# Groundwater Application Review Summary Form

Application # LL- 1872 Re-Review

SUBJECT: Application LL- 1872 Re-Review Supersedes review of 11/15/2021
Date of Review(s)

A. GENERAL INFORMATION: Applicant's Name: Avion Water Co. Inc. County: Deschutes

Figure 2. Hydrograph of groundwater elevations from the Sisters area through the Deep Canyon area. DESC 2000 and DESC 1416 are 0.8 and 2.9 miles from the proposed POAs, respectively.

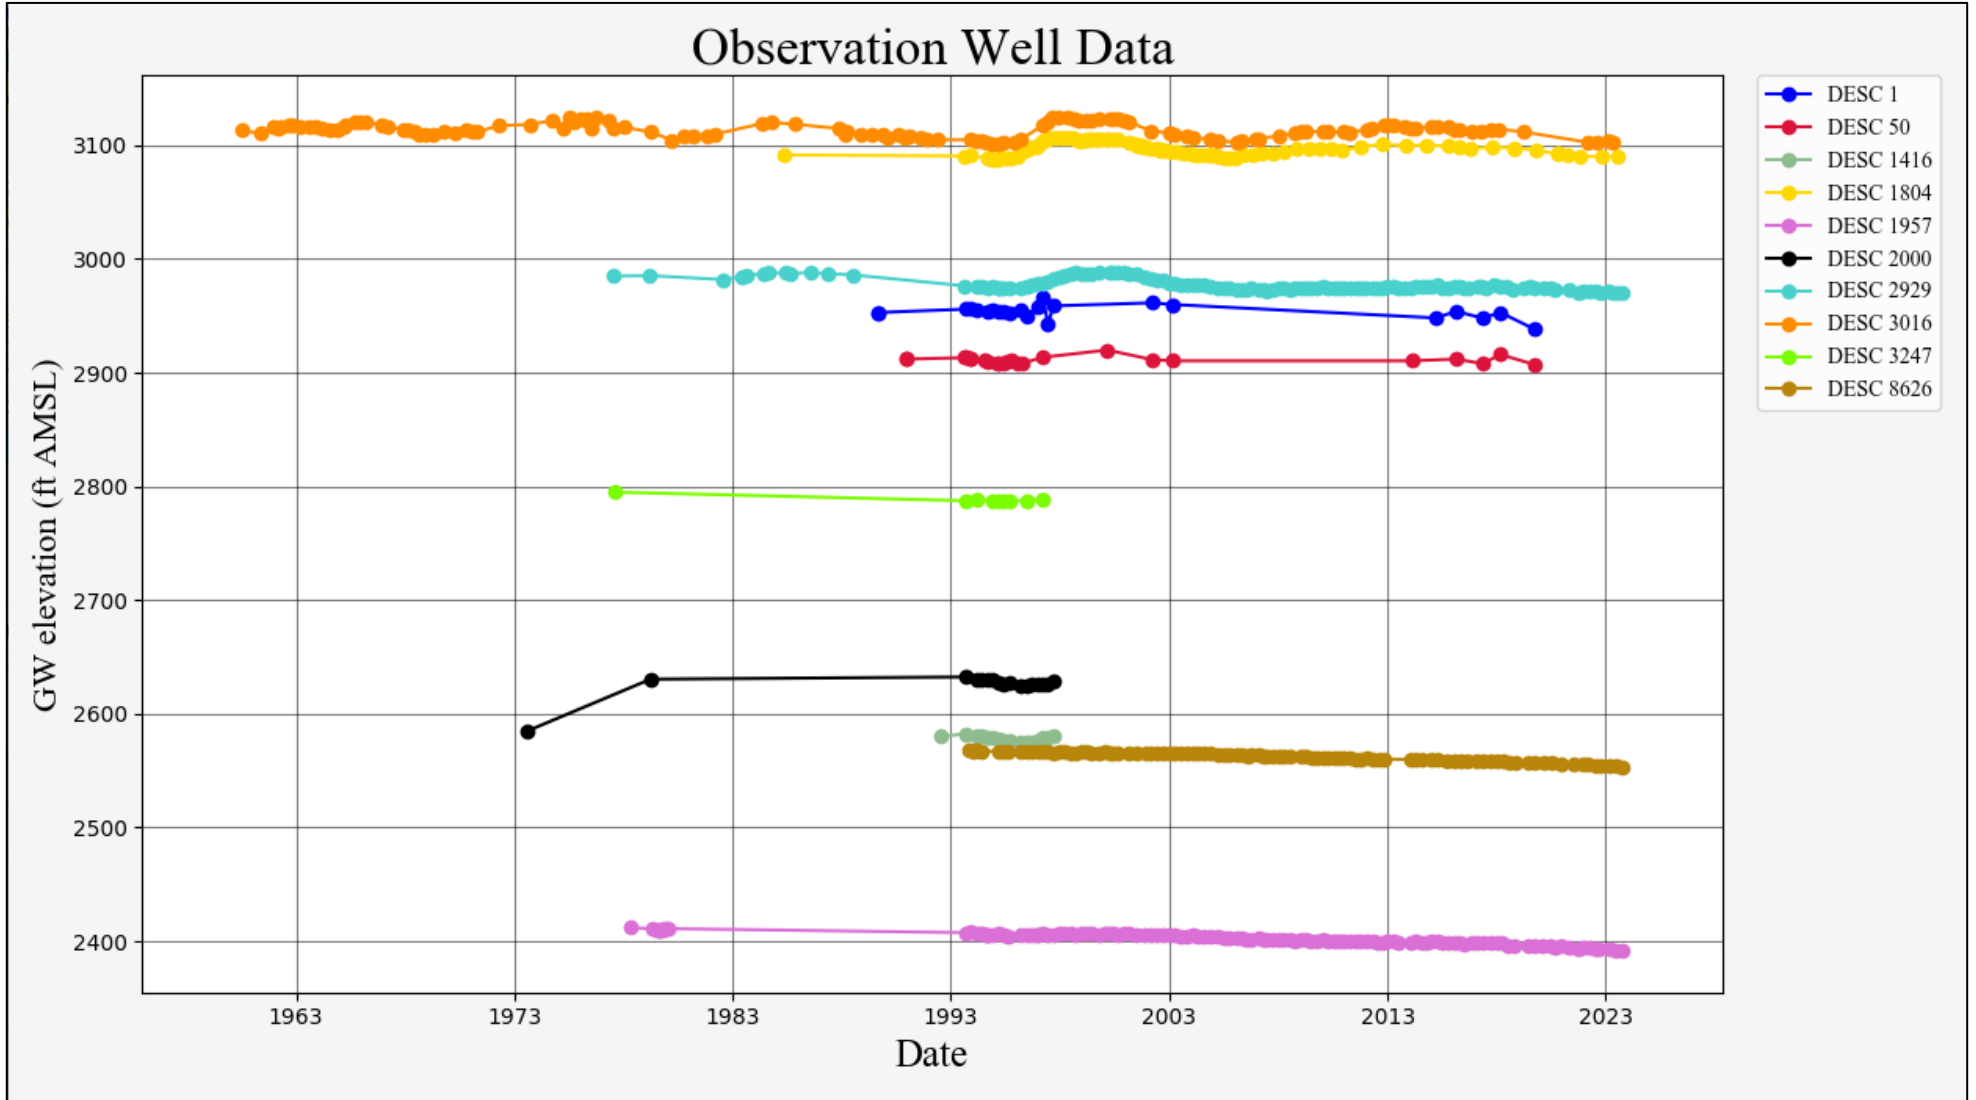
Several wells to the east of the proposed POAs (referred to as the “Deep Canyon Area” in Map 1) have shown persistent year-on-year declines totaling ~13 feet from 1994 to 2023 (see Figures 3 and 4). Studies by the USGS and OWRD have attributed these long-term declines to 1) long-term climate change, 2) groundwater pumping (see Figure 2), and 3) canal lining causing reduced recharge. The nearest well (DESC 1957) exhibiting this trend is approximately five miles to the east of the proposed POAs. Wells upgradient in the groundwater system from the city of Sisters (e.g. DESC 3016 and DESC 1804) show 10-20 feet of oscillation that tracks largely with decadal climate cycles. Current groundwater levels in those wells are at or near the same elevation as 1994. Just downgradient (NE) of Sisters, water levels in DESC 2929 rise 12-13 feet

in response to the heavy precipitation of the late 1990s but respond very little to increased recharge in the early 2010s. Current water levels are ~5 feet lower than in 1994. There are no long-term observation wells immediately adjacent to the proposed POAs that show water level trends there. Because the proposed POAs are located nearly equidistant between DESC 2929 and DESC 1957 in the same groundwater system, this review assumes that water levels at the application site show an intermediate of those two trends. Specifically, water levels have likely shown declines since approximately 2000 on the order of 5-10 feet.

Prior to use under this Limited License, each POA shall be equipped with a method for measuring static water level and a reference water level must be provided to the Department. This can include an airline, measuring tube, or any other construction or equipment that allows access to report static water level measurements. The chosen water level measuring method shall be maintained in proper working order as to allow static water level measurements for the duration of the Limited License.

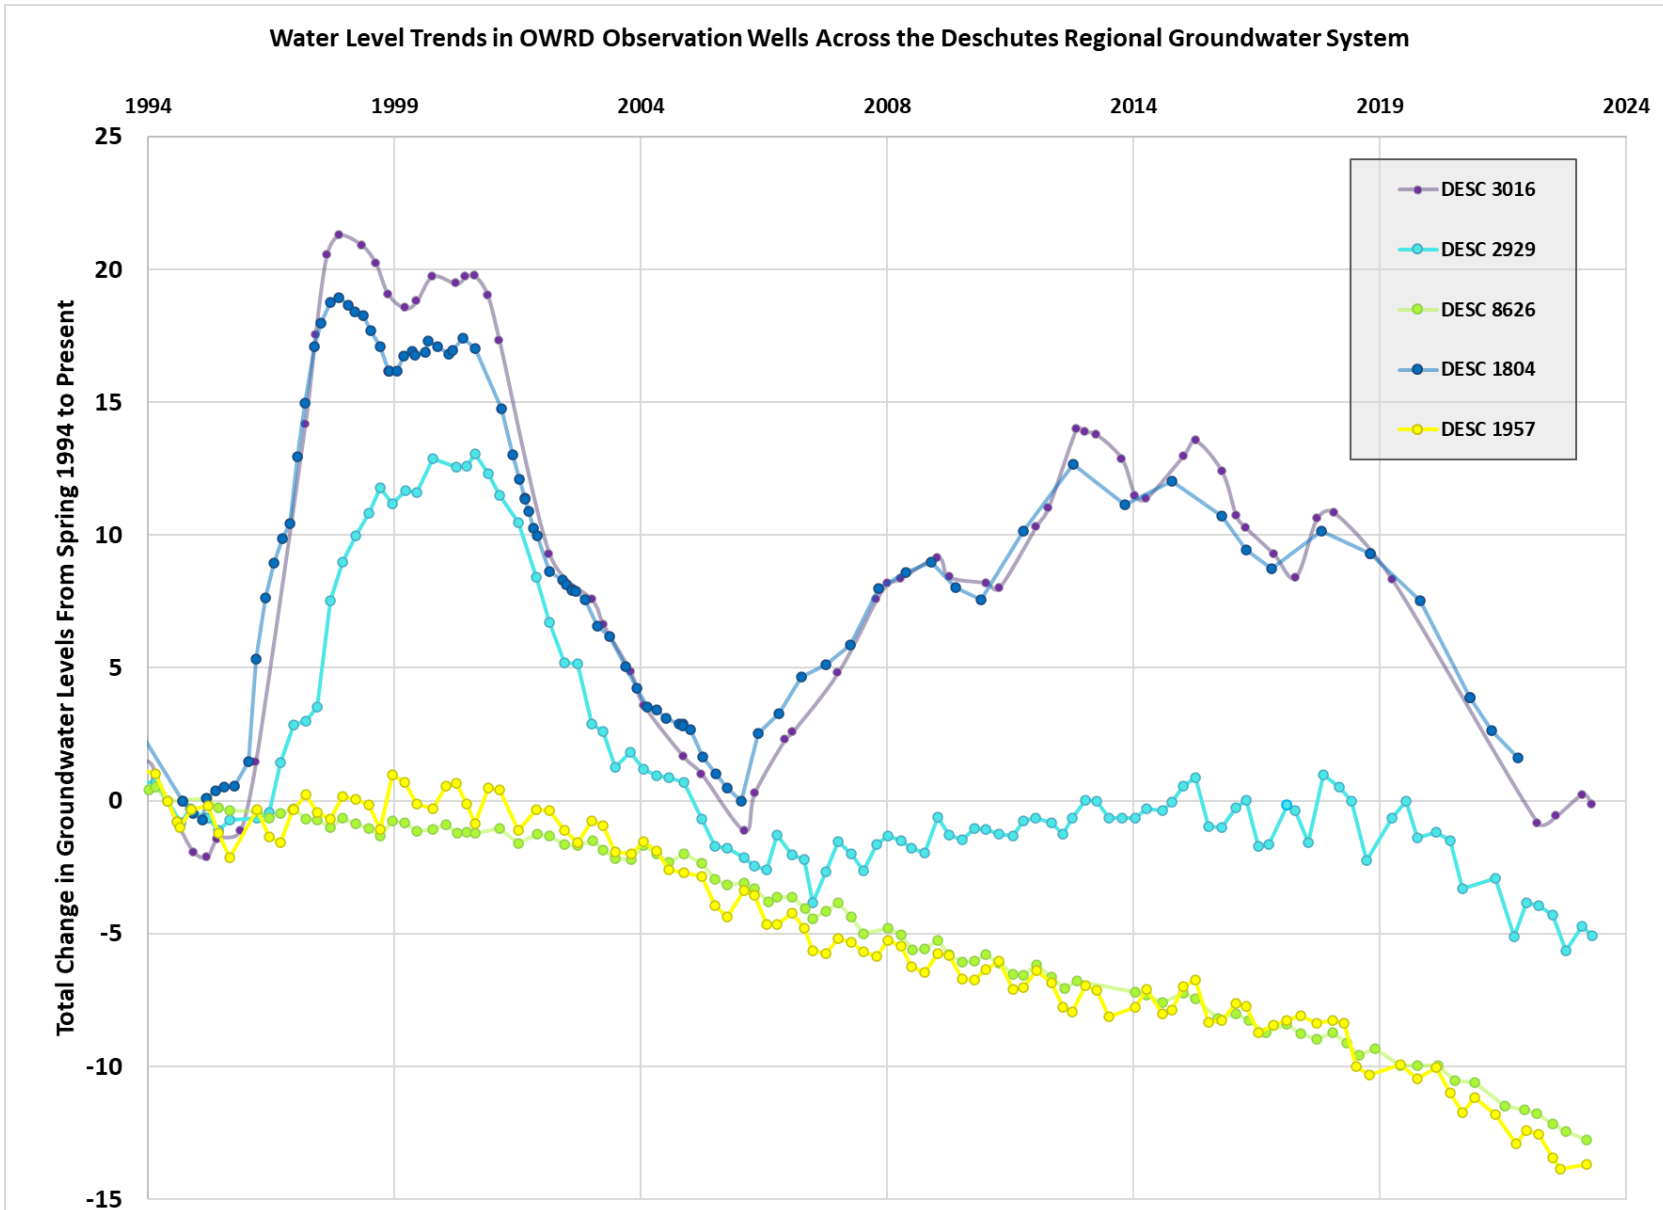
The wells in the Deep Canyon area showing long-term water level declines are located generally down-gradient of the proposed POAs and thus farther from recharge zones for the region. Pumping under the proposed right would reduce recharge to the Deep Canyon Area by intercepting the dominate groundwater flowpaths to this area, thus exacerbating the declines there. However, considering the low-moderate magnitude of declines observed in the Deep Canyon area and assumed at the proposed POAs, the preponderance of evidence indicates that the proposed use is within the capacity of the resources. There best available water budget estimates from USGS basin study reports indicate that the resource is not over-appropriated. In light of the lack of data in the area and concern about longer term declines, the permit conditions listed in Section B(d) are strongly recommended.

**Figure 5: Extract from Gannett et al. (2017); results of modeling impacts from pumping a well completed in the Deschutes Formation aquifer on nearby surface water reaches; purple squares show the impacted model stream cells.**

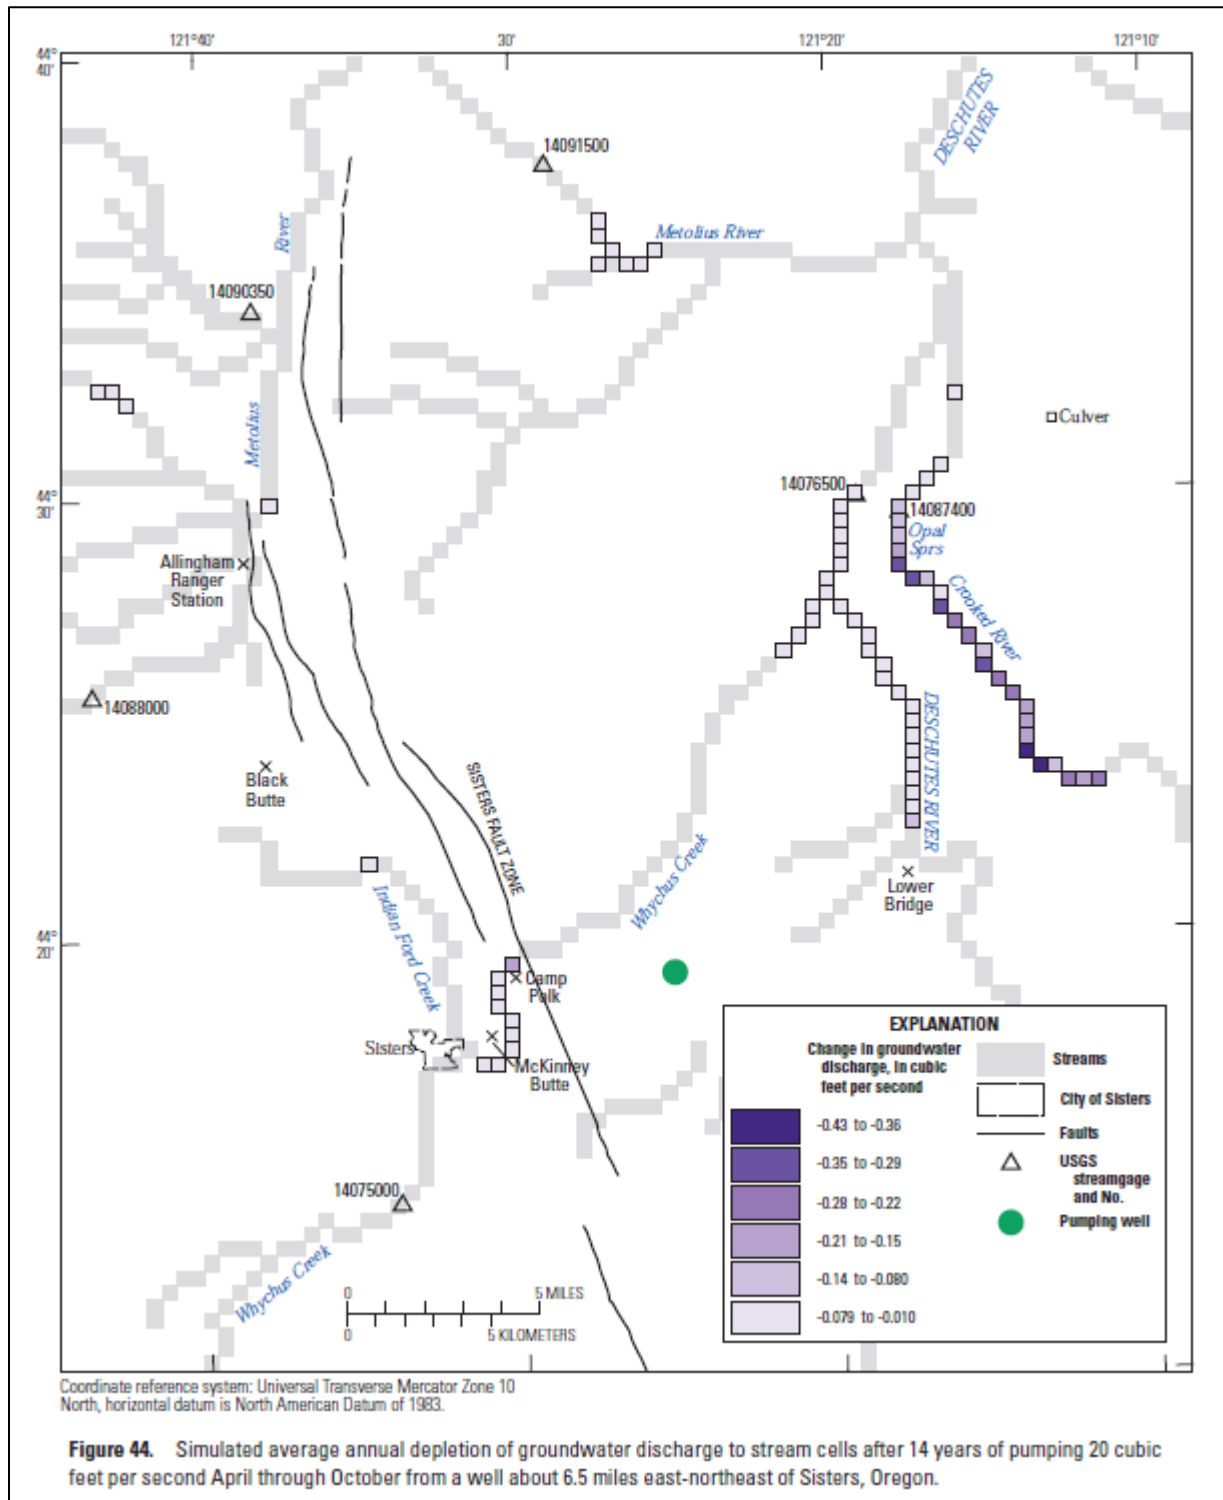
**Basis for impact evaluation:** Analytical stream depletion models, such and the Hunt-1999 model, would not be appropriate at this distance, so stream depletion was based on the results of modeling done as part of the USGS Scientific Investigations Report 2017-5097 (Gannett et al., 2017). Specifically, pages 61-63 describe modeling stream depletion impacts from pumping a well near the area of the proposed POAs and Figure 44 and 45 show the impacts to Whychus Creek, the Deschutes River, and the Crooked River. The analysis estimates that stream depletion will be less than 5 % after 1 year of pumping for all three surface water sources. The resolution of the figure is too coarse to confidently pick out stream depletion less than 5% and less than 1 year so those values are used in the table.

**C6. SW / GW Remarks and Conditions:** Studies in the Deschutes Basin have shown that there is strong hydraulic connected between groundwater and surface water in the area of the proposed groundwater POAs but that there is little hydraulic connection in the immediate vicinity. Instead, groundwater flows hundreds of feet below land surface in the middle part of the Deschutes Basin, an area extending from near the Sisters Fault Zone to near the confluences of the Deschutes River, Crooked River, and Whychus Creek. These same studies have shown that nearly all groundwater flowing through the area does discharge back to surface water so the total impact from pumping near the proposed groundwater POAs will, over time, likely reach 100% of the pumping. However, in the short time scale considered in this review (limited to assessing impacts within 1 year) the impact to surface water is estimated to be less than 5% of the pumping rate and so is not considered to have the Potential for Substantial Interference with surface water per OAR 690-009 rules.
